Correction to Module Cooling
A. Wehmann
5/1/02

I believe I have found an error in the calculation Bruce Baller did for module cooling in the case of no water flow to either module #3 or #4 on the NuMI absorber¹. Here is an extract from Bruce's email (*italics*).

Figure 1: A log-log plot of the heat transfer coefficient vs delta t

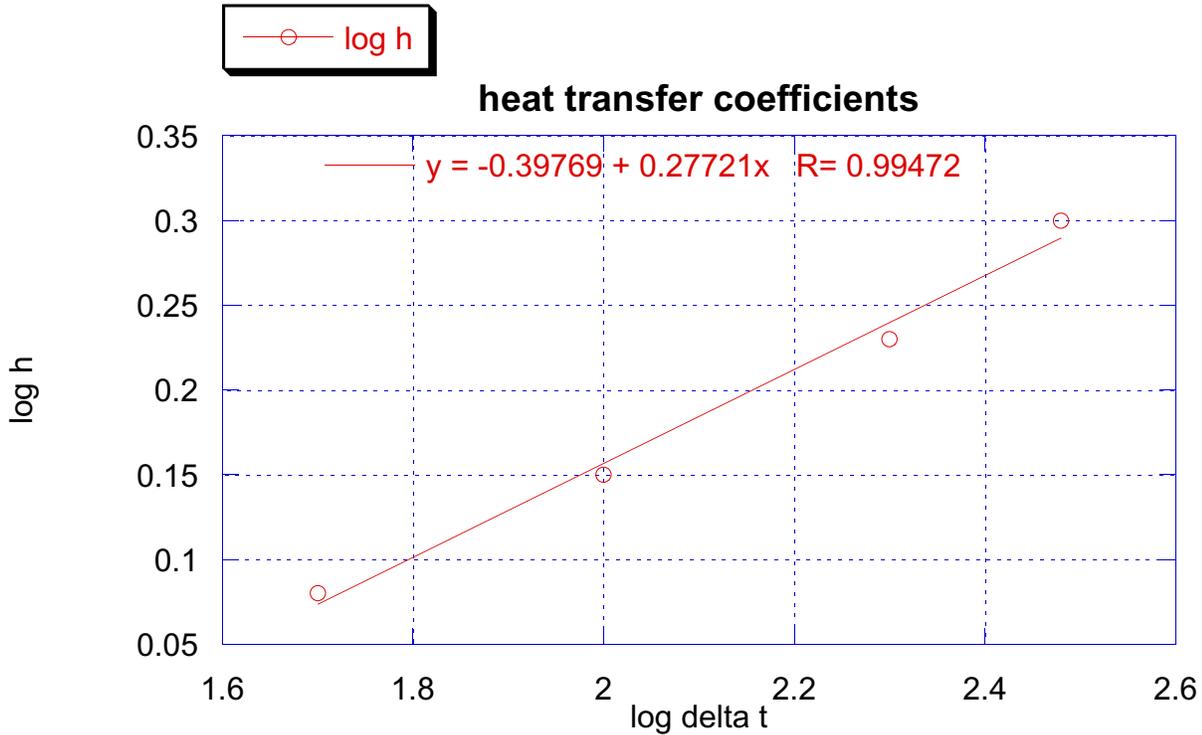
Figure 1 is a plot of the log of column B of Table 2 versus column A of Table 2. A text I have at home by Zemansky states that the natural convection heat

transfer coefficients vary as $(\Delta t)^{\frac{1}{4}}$; the linear fit in Fig. 1 suggests that the coefficients from Column B vary with t almost in that manner². The linear fit was used in column G of Table 2 in order to extrapolate³ to a delta T value of 400 degrees F.

Figure 2: Module Cooling

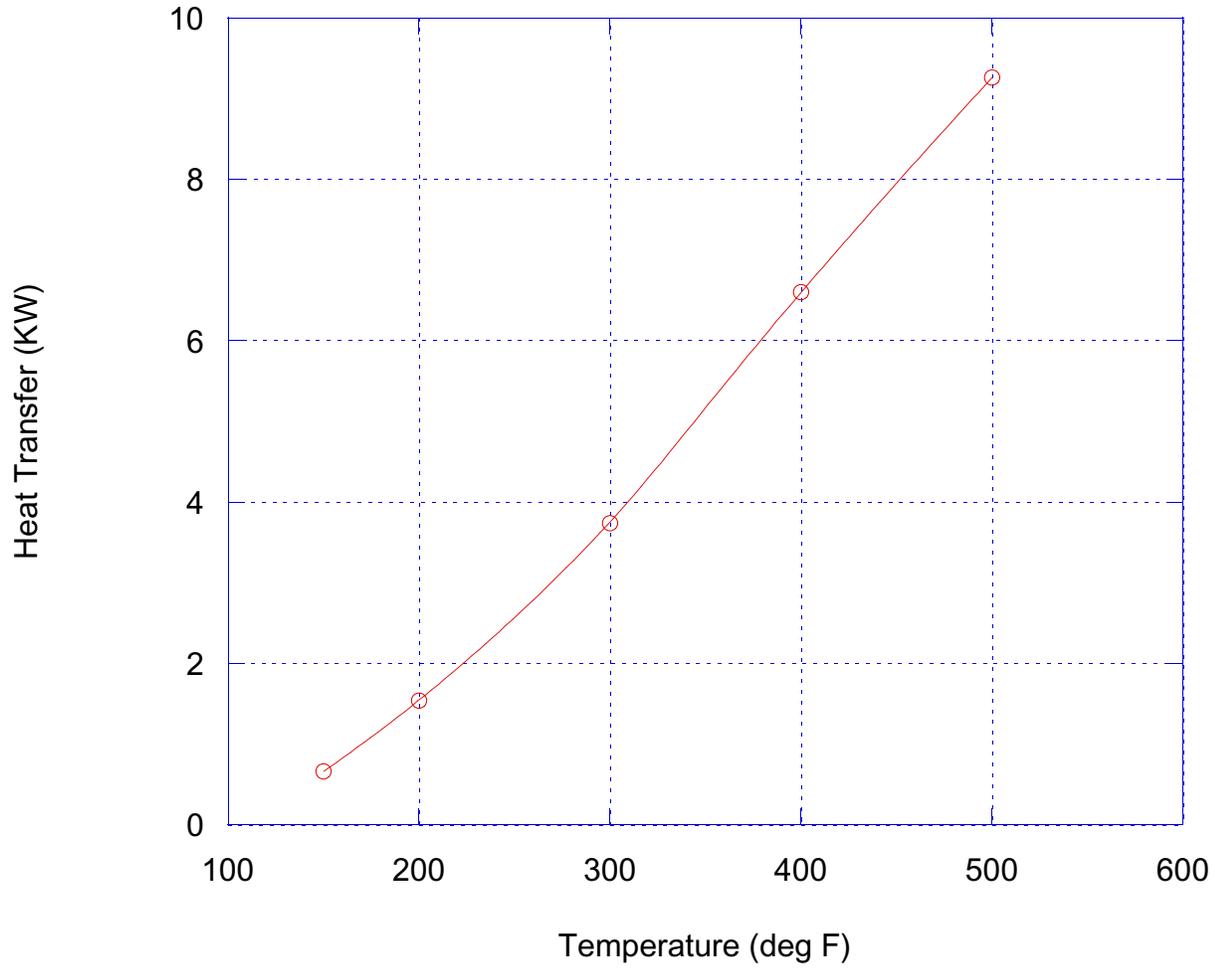
Finally, Figure 2 shows a new plot of heat transfer from the module without water cooling versus temperature:

Reading from Figure 2, 8 KW corresponds to 450 °F.
